DESIGN ADVISORY BOARD
Tuesday, July 14, 2015 at 3:00 PM
Conference Room 12, City Hall, Burlington, VT

To: The Historic Preservation Review Committee
From: Mary O'Neil, AICP, Senior Planner, CLG Coordinator
RE: 86 Lake Street, Section 106 Review
Date: July 14, 2015

To: The Historic Preservation Review Committee
From: Mary O'Neil, AICP, Senior Planner, CLG Coordinator
RE: 131 Main Street, Section 106 Review
Date: July 14, 2015

To: The Historic Preservation Review Committee
From: Mary O'Neil, AICP, Senior Planner, CLG Coordinator
RE: Address provided as 720 South Prospect Street, Section 106 Review
Date: July 14, 2015

ANTENNA MOUNTING VIEW (1/04)
SCALE: 1" = 1'-0"

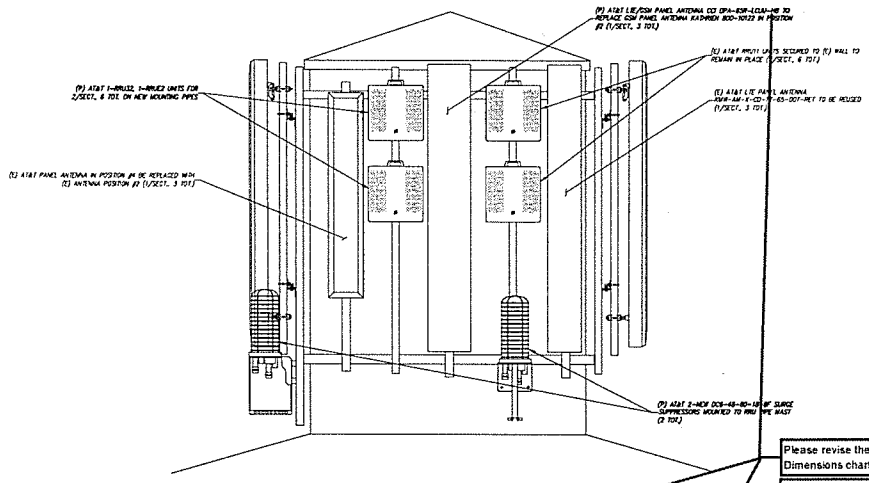
Please revise the proposed antennas in the Project In
Dimensions chart to reflect the correct model and mea

Once the proposed antenna information and dimensions are corrected, please revise the calculations as necessary.
